Memorandum

Date	03/07/2025
Authors	Djordje Petkovic (Vineway Ltd); Cam Wallace (Barker & Associates); James McKenzie (McKenzie & Co); Hunter Abernathy (Commute Ltd)
Matter	Delmore – Fast-track Approval application – Collector Roads

Introduction

Figure 1 - "Mini Neighbourhoods" (yellow) in relation to the NOR6 Road and Watercourses. Source: B&A.

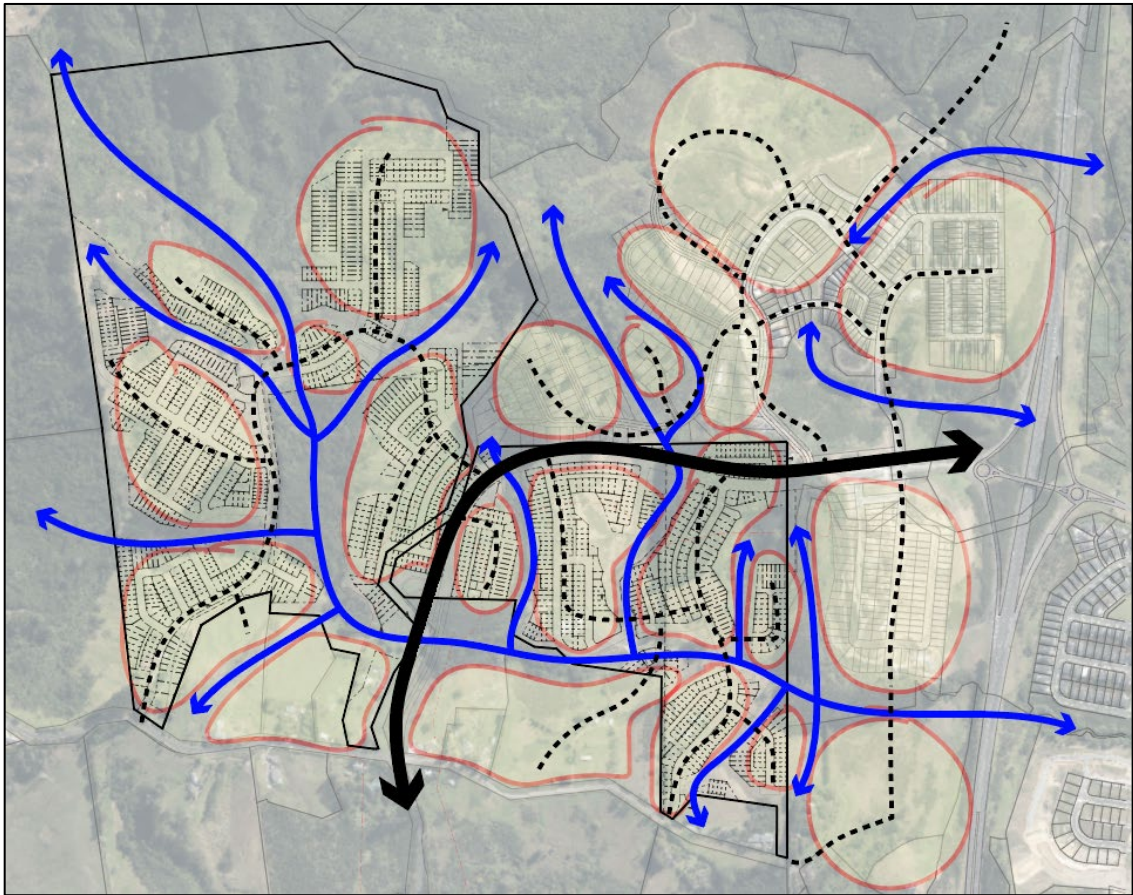
1. Auckland Council's feedback on the substantive application for approvals for Delmore states that "...the proposal does not provide an appropriate road hierarchy with the one arterial road (NoR6) and 28 local roads," and contends that a collector road must be included in each development Stage along Roads 1, 24, 14 and 5).¹
2. It is not agreed that collector roads are required for the reasons set out in this memorandum. The reasons for this are multi-disciplinary, so this memorandum has been prepared jointly by Commute Ltd, McKenzie & Co, Barker & Associates (urban design), and Vineway Ltd's in-house architect.

3. The topography of the site, in combination with the location of watercourses and protected bush / SEAs, along with the alignment of the NoR6 Road are the defining characteristics which inform the resulting block structure and street network. When considered together, these characteristics effectively result in a pattern of development that could be characterised as a series of small, interconnected "mini neighbourhoods" of no more than 200 to 300 dwellings as demonstrated schematically in **Figure 1** below. As a result, fairly low vehicular traffic volumes on local roads throughout the development are anticipated.

4. All roads across both the Delmore development and Ara Hills eventually converge / meet with the NoR6 Road which will eventually provide exit points from the Upper Orewa Area in two locations – at Grand Drive (over SH1) and at Wainui Road (via Upper Orewa Road). As such, the internal road network (across the Upper Orewa Area in general) does not (and cannot) provide wider sub-regional connectivity. Those roads now requested to be amended to collector roads are considered to be of low strategic network significance. They primarily provide local access

for residents consistent with the function of a local road, whilst still providing for some internal connectivity across the development.

Figure 2 - Projected Vehicle Flows on both Collectors. Source: Commute

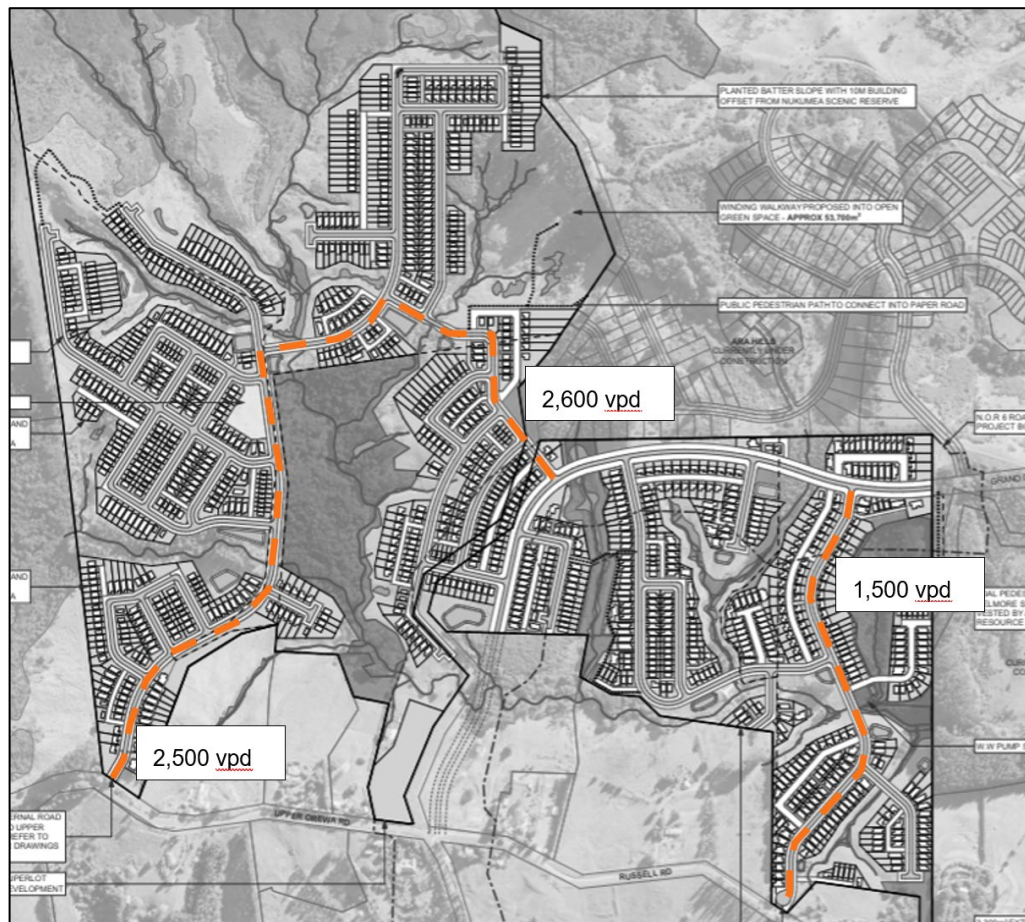
12. Both stages / potential collector routes have been reviewed in relation to traffic volumes and the following is noted:
 1. Stage 1 accommodates approximately 470 dwellings. However, not all would use Road 1 (potential collector road) due to other routes available to the NoR6 arterial Road (eg Road 2 and Road 3). It is estimated that 50% of these dwellings would use Road 1, or 240

dwelling. Using the RTA daily trip rate of 0.65 daily trips per dwelling, this equates to 1,500 vehicle per day on Road 1 (maximum at its northern end).

2. Stage 2 accommodates approximately 780 dwellings. Stage 2 does however have two “links”, one to the NoR6 road (Road 5) and one to Upper Orewa Road (Road 17). As per the Item 2 above, approximately 30% (380 dwellings) of the total Delmore site is expected to use Road 17 to access Upper Orewa Road (via a new roundabout). As such the other 400 Stage 2 dwellings will use Road 5 to link to NoR6 Road, essentially resulting in a 50/50 split across Stage 2. As such both these roads will accommodate 2,500-2,600 vpd (0.65 daily trips per dwelling). Figure 2 below summarises the projected traffic volumes arising from the proposal.

13. When considering the above, it is noted that collector roads and separated cycle lanes are generally only considered to be required on roads which have volumes of over 3,000 vpd, as set out within Auckland Transport's Roads and Streets Framework (pg 33-50). Overall, both the Stage 1 and Stage 2 collector routes will not need to cater for more than 3,000 vpd with either the Delmore or future development of adjoining FUZ land. As such, collector roads are not considered to be required on transport grounds and the proposed roading hierarchy is considered to be appropriate.

Figure 3 - Accessibility to (indicative) Bus Stops on the NOR6 Road. Source: B&A.

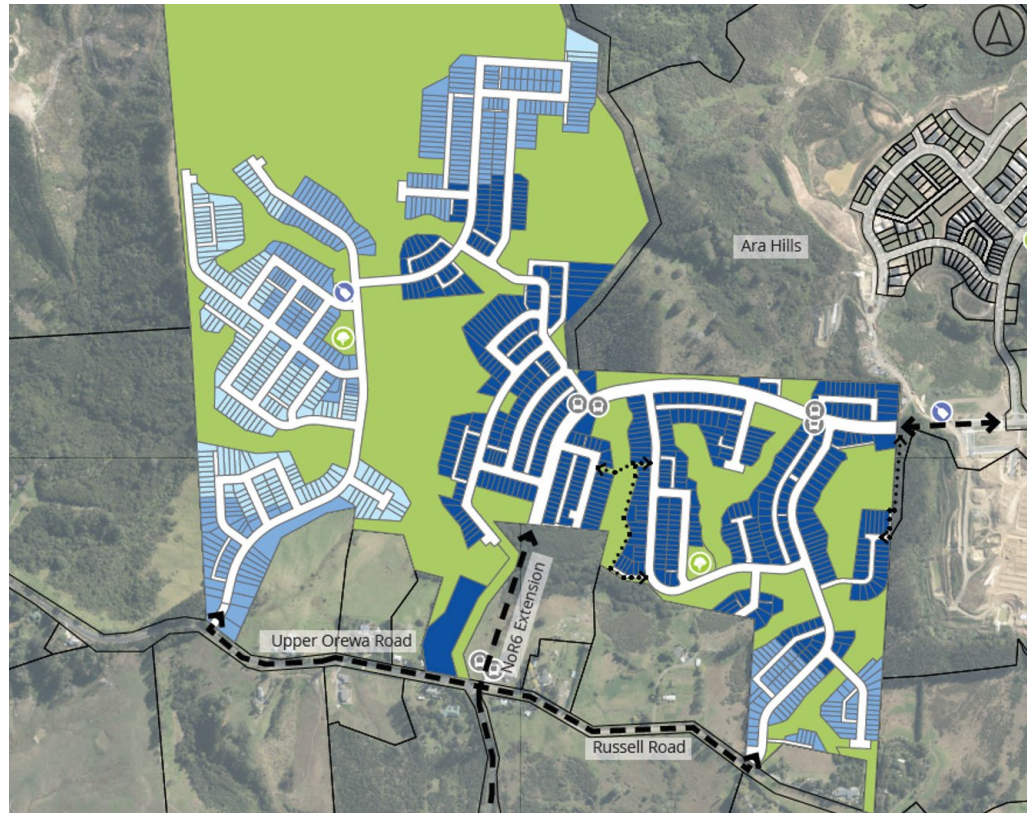
14. In terms of public transport, **Figure 3** below shows the lots' proximity to bus stops on the NoR6 road (FTN bus route) assuming three pairs of bus stops near the intersections of Road 1 and Road 5 and Upper Orewa Road. Auckland Transport "Urban Streets and Roads Design Guide" notes an acceptable travel time of a 10 minute-walk to a Frequent Bus Service (which will be operating on the NoR6 in the future).

- Dark blue identifies lots within a 500m walking distance (6 minute) to the FTN bus route bus stops (51% of lots);
- Medium blue identifies lots within 800m walking distance (10 minute) to the FTN bus route bus stops (further 30% of lots); and
- Light blue identifies lots beyond this distance (19% of lots).

16. We further note that all of Stage 1 is within a 10 minute-walk to a (future) Frequent Bus Service and thus a bus route through Stage 1 is not required. The Regional Public Transport Plan (2023-2031) (RPTP) targets (pg.45) having 42% of the population living within 500m of an FTN across the "North Region" by 2031. The proposal easily meets this target, with 51% of lots provided within this range. The 19% of lots (ca. 231) not covered above are all in Stage 2 are mostly at the edge of the site adjacent to the RUB. Even if a local service was provided via Road 17 most of these 19% of lots would still be located 200-500m from any reasonable stop location and thus an additional fixed-route service (likely at much lower frequencies than an FTN service) would not appreciably improve access via public transport.
